EMERGENCY ALERT SERVICE BULLETIN

Tail Gear Box (TGB) P/Nos. 365A33-6005-09 and 365A33-6005-10

ATA 65

Revision No.	Date of issue
Revision 0	2019-10-24
Revision 1	2019-12-11
Revision 2	2020-03-25
Revision 3	2021-06-14
Revision 4	2021-09-22

Figure 1: Example of abrasion on the chip detector

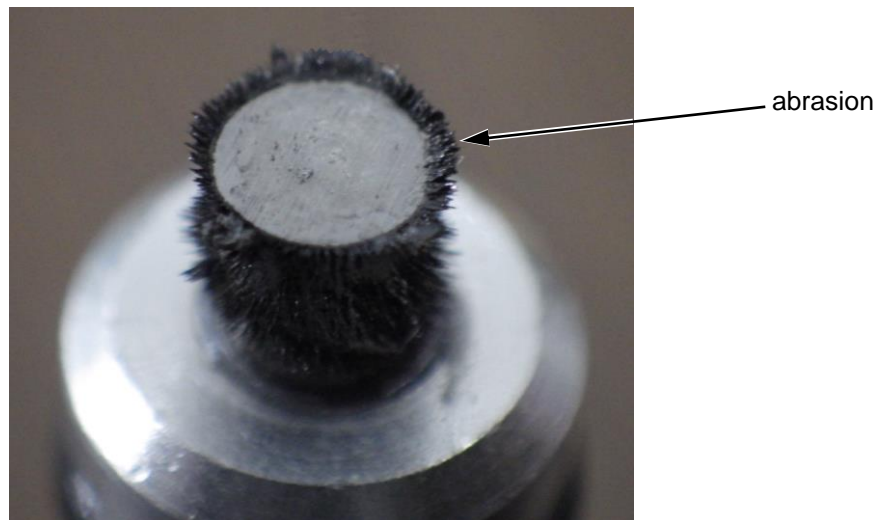
IN THE FLOW CHART, THE ABRASION PARTICLES (CLASS g AS PER MTC) MUST BE TAKEN INTO ACCOUNT IN ADDITION TO THE PARTICLE TYPES USUALLY TAKEN INTO ACCOUNT.

Are there **abrasion** (as per example in Figure 1)/scale/chip/splinter type particles or particles different from cotter pins, lockwire, swarf, various non-metallic debris ?**

3.B.2. Check of the manual chip detector or chip detector with electrical indicating of the TGB

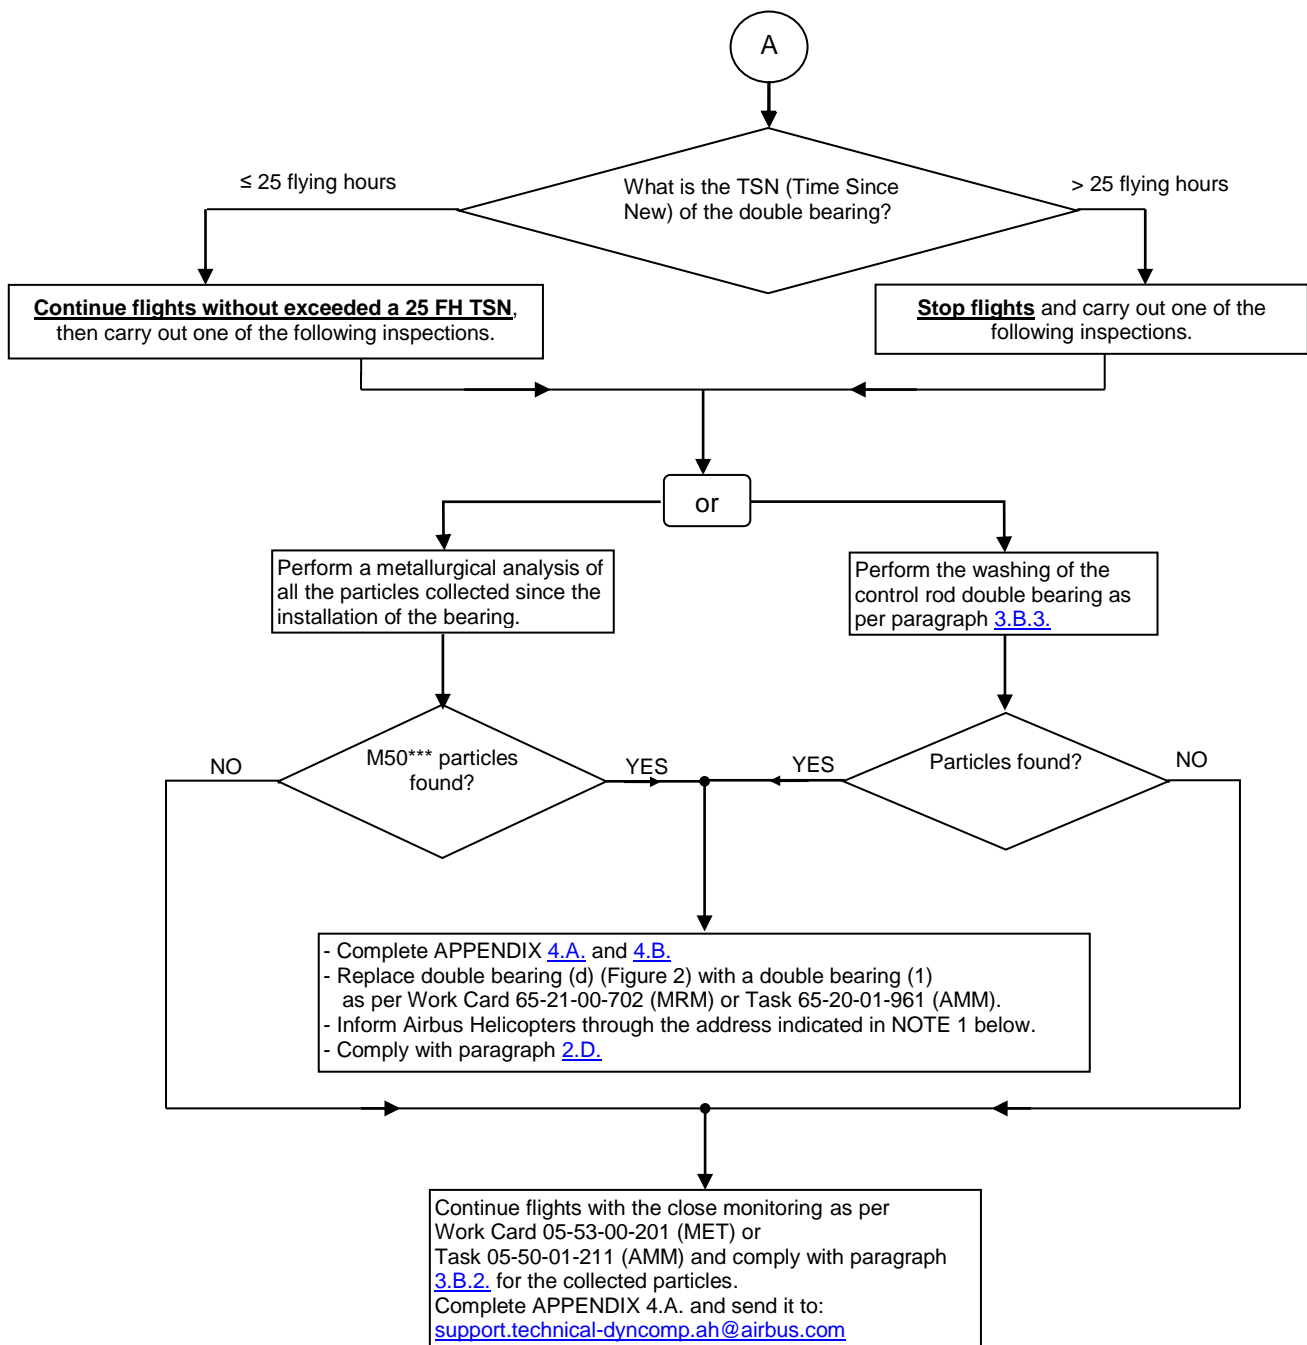
Comply with paragraph F.2.a/b/c as per Work Card 05-53-00-201 (MET) or Task 05-50-01-211 (AMM).

Define the type of particle(s) as per Work Card 20-08-01-601 (MTC)*.

Is a removal criterion of the module reached as per Work Card 20-08-01-601 (MTC)?

Remove the TGB as per technical documentation

Comply with the procedures of Work Card 20-08-01-601 (MTC)*

Figure 2 (Washing of the double bearing)

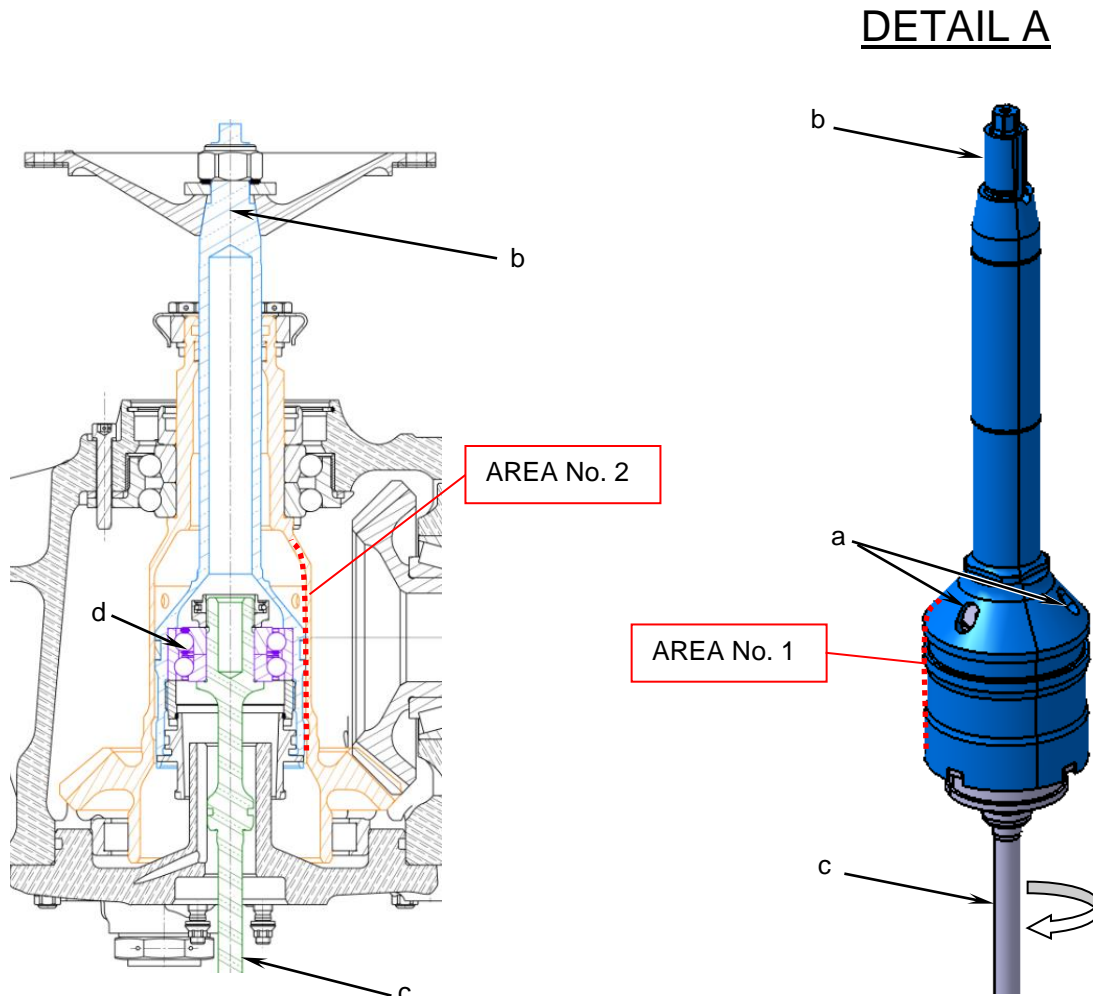
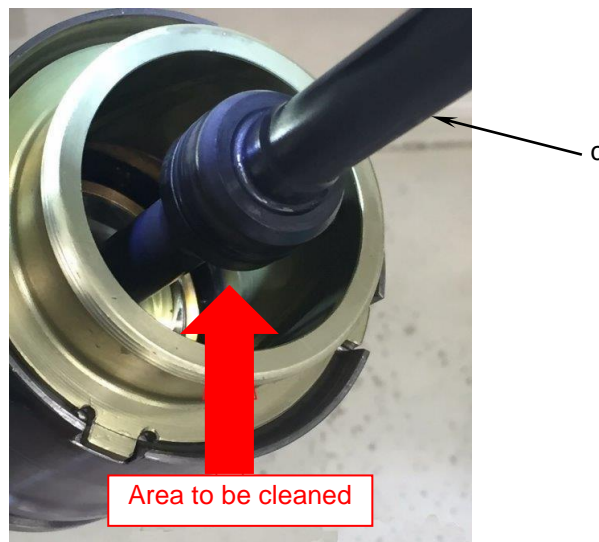
- 1) Insert WHITE SPIRIT (2) under pressure (for example using a can) in the hole (a) of the control shaft (b). **(See [DETAIL A Figure 2](#)).**
 - . Manually turn the control rod (c) several times to wash the double bearing (d) by draining the WHITE SPIRIT (2) through the bearing. **(See [Detail A Figure 2](#)).**

- 2) Insert WHITE SPIRIT (2) (for example using a can) in the area of the control shaft (b) that must be cleaned. **(See [DETAIL B Figure 2](#)).**
 - . Manually turn the control rod (c) several times to wash the double bearing (d) by draining the WHITE SPIRIT (2).

Make sure that the area pointed out in [DETAIL B Figure 2](#) is clean.

Figure 3

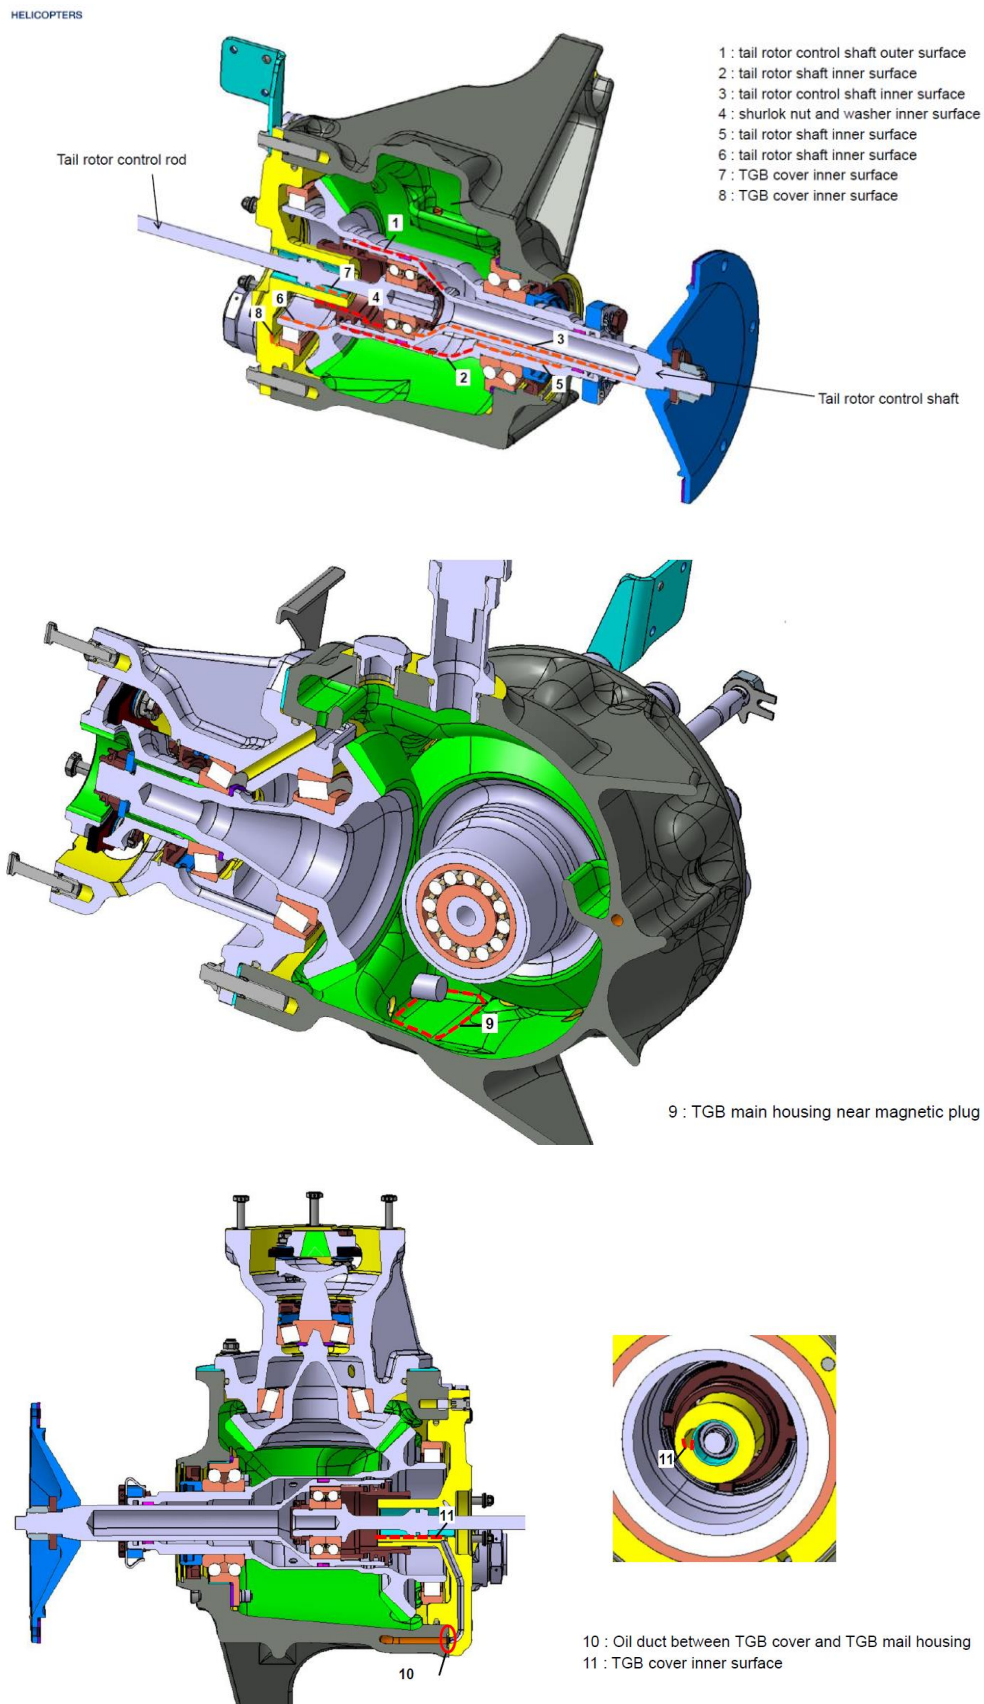
- Check that there are no particles in the lubrication hole of the TGB cover (Area No. 11, [Figure 3](#) of APPENDIX 4.B.).
- Install the TGB control shaft/rod assembly as per Work Card 65-21-00-701 (MRM) or as per Task 65-20-01-066 (AMM).

Complete APPENDIX 2 (see [Figure 3](#))
